Ref: 1.MoEF&CC File No: IA-J-11015/82/2021-IA-II(NCM)

2.Proposal No : IA/KL/MIN/232178/2021

3. 6th EAC (Non-Coal Mining) meeting held during 9th – 11th November, 2022.

Sub: Seeking Environmental Clearance for Proposed Granite Building Stone Quarry of Morayoor Granites Pvt Ltd which is situated at Re Survey No.152/1-1, 152/1, 159/1-1, 159/1-2, 159/1-3, 160/1-1, 160/1-2, 160/1-3, 160/1-4, Re Survey Block No. 56 of Morayur Village, Kondotty Taluk, Malappuram District, Kerala for an area of 4.9797 hectares under B2 category.

Site Preparation and Bench Height Formation

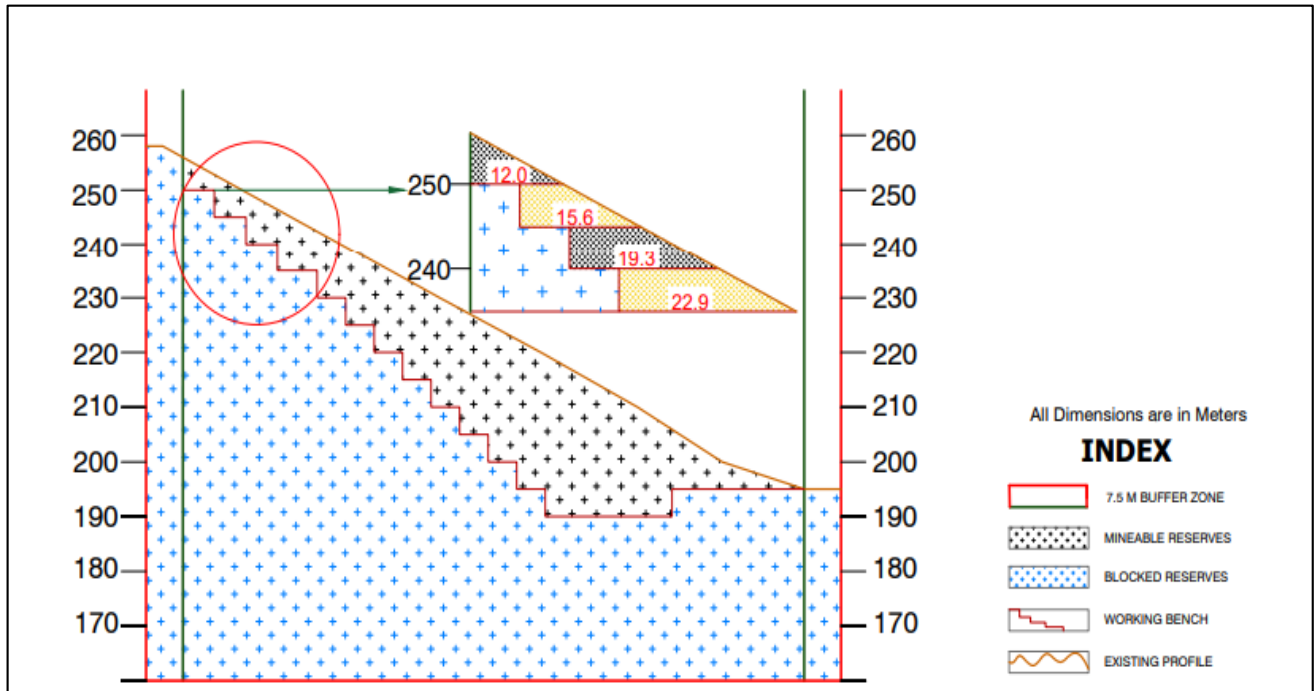
1.The EAC noted that the production by jack hammer drilling is not sufficient to produce 650 TPD. The EAC asked the Project Proponent to revisit the methodology of the mining adopted specifically relating to Bench height, Drilling and Blasting and accordingly the project proponent needs to submit the comprehensive note on methodology of mining with proper justification. Accordingly, the mining plan needs to be revised.

1. Remove the soil cover and expose the rock
2. Remove the loose boulders with the help of excavator and prepare free face for drilling
3. To develop haul road from the proposed quarry using natural gradient of the hill for movement of tippers
4. Drill holes of 32mm diameter and 2.6m in depth will be made using Jack Hammer. The spacing and burden will be kept at 1m
5. To reduce the noise levels will be blasted by using nitrate mixture and millisecond delay detonators
- 6 About 48 holes will be blasted in one blast
7. Number of blast per day will be 2 no's and totally blast of 96 holes per day.
8. Give proper layout to the bench. To maintain the bench height of 5m, sub-bench of 2.5m will be formed first, later on two benches of 2.5m will be merged and one bench of 5m will be formed and maintained. The detailed figure of Bench Height Formation provided below.

- In the initial stage of mining, the work will be carried out from 250m MSL-255m MSL. In this bench, width of the bench is 12m which is sufficient for the machinery operations. After completing the working operations in the first bench, the width of the bench will be reduced to 5m, while works start at immediate below bench (245-250m MSL)
- Similarly, in the further stages of mining, the width available for the safe mining operations at 245m MSL, 240m MSL and 235m MSL will be 15.6m, 19.3m and 22.9m respectively.
- The same mining process is carried throughout the mining operation thereby sufficient working space will be available during the operational phase which will reduce the risk of accidents.

Figure 1: Traffic Study Locations

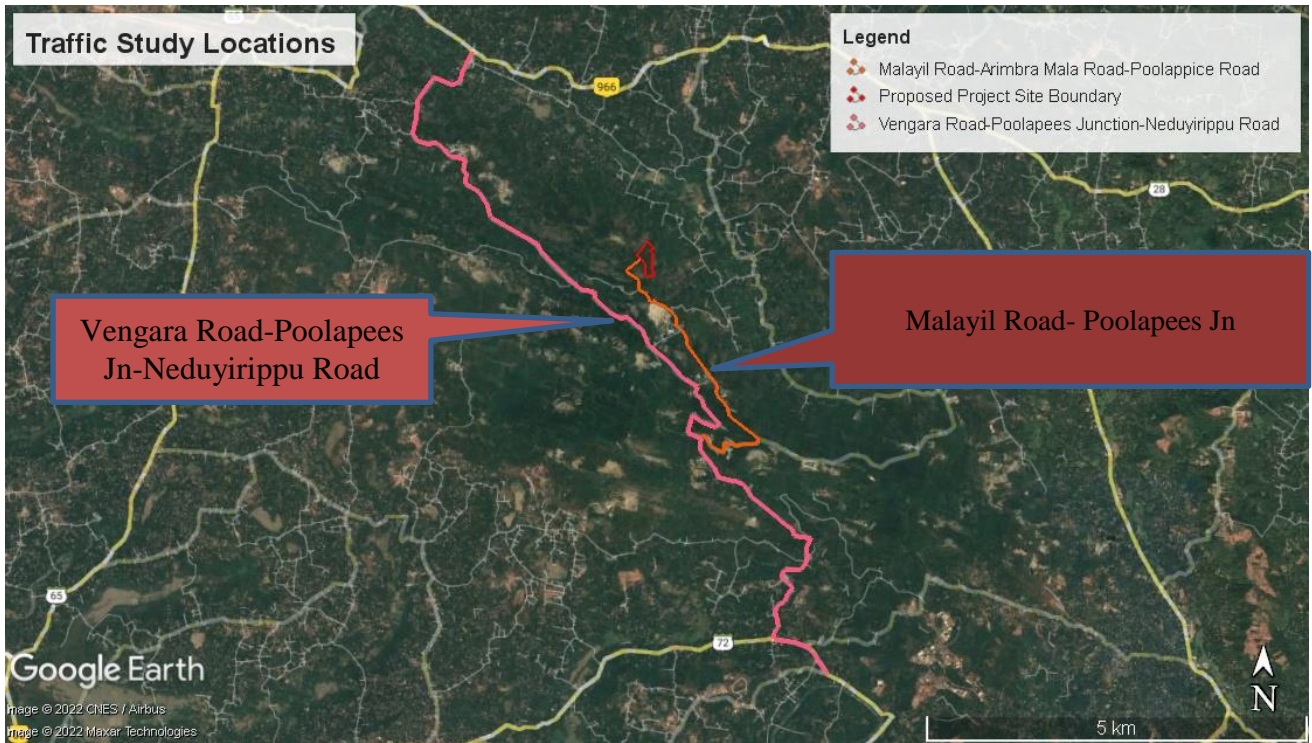
2.The EAC opined that the proposed transportation is passing through the village road and hence asked the Project Proponent to conduct the traffic study as the PP is proposing to transport 140-150 no.of trips/day and also the measures and action plan to be taken to strengthen and maintenance of the approach road. PP should explore the possibility of bypassing the village road for transportation purpose and accordingly submit the map for transportation route.

A Traffic Study was conducted to determine the vehicular traffic measures and best possible route for material transportation from mines to destination points. It is proposed to take the material to different destination in routes.

Currently we had proposed, the approach road from the quarry site can be accessible via Arimbra – Morayur road a village road which is connected to NH966. Since the existing proposal was changed because the road passes through a populated area. Hence instead of this Road, alternative route was considered for the Traffic Study which is currently using regular truck movement with sufficient capacity. The approach road connects the proposed project site with Malayil Road and then it reaches the Poolapees Junction where it connects to Vengara Road-Poolapees Junction-Neduyirippu Road, connects NH 966. Both stretches have a minimum width of 7m which is sufficient to cater the additional traffic loads expected from the proposed project.

Figure 04: Google Image of Afforestation proposed outside of the Lease Area

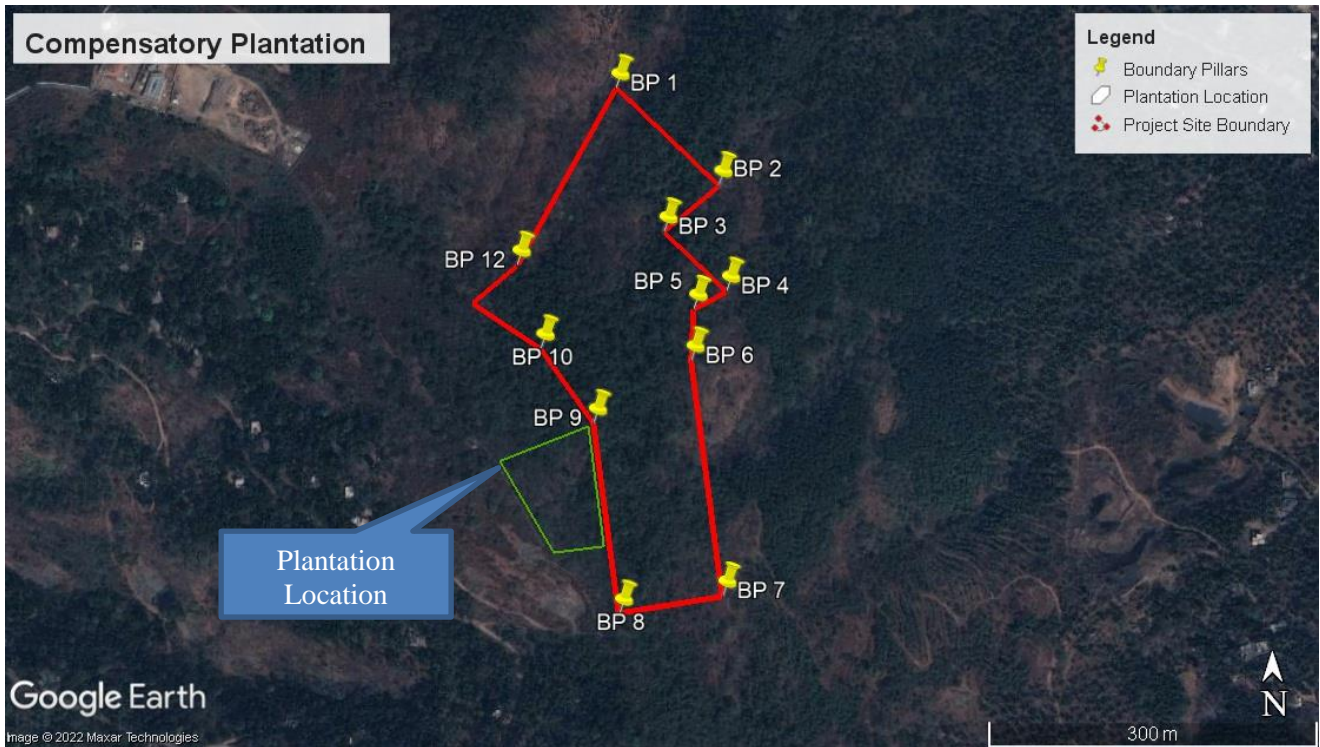
3.The Project Proponent needs to refer the Central Pollution Control Board (CPCB) Guidelines for developing greenbelts and to rework on the spacing proposed for development of greenbelt and also to provide the no. of trees cut in the mine lease area and the compensatory afforestation plan, along with the no. of species to be planted and the type of species to be planted.

As a compensation of loss of trees within the core area, plantation will be carried out side the lease area, more in the dry area in Survey No 160/1-2 for an area of 0.6516Ha. Yearly, we will plant about 217no's of trees for 5years. Totally we will plant around 1085no's of trees within the same area, expecting survival rate of 90-95% with a plant interval of 2x3m wide. Five year afforestation plan outside the quarry area is as follows.
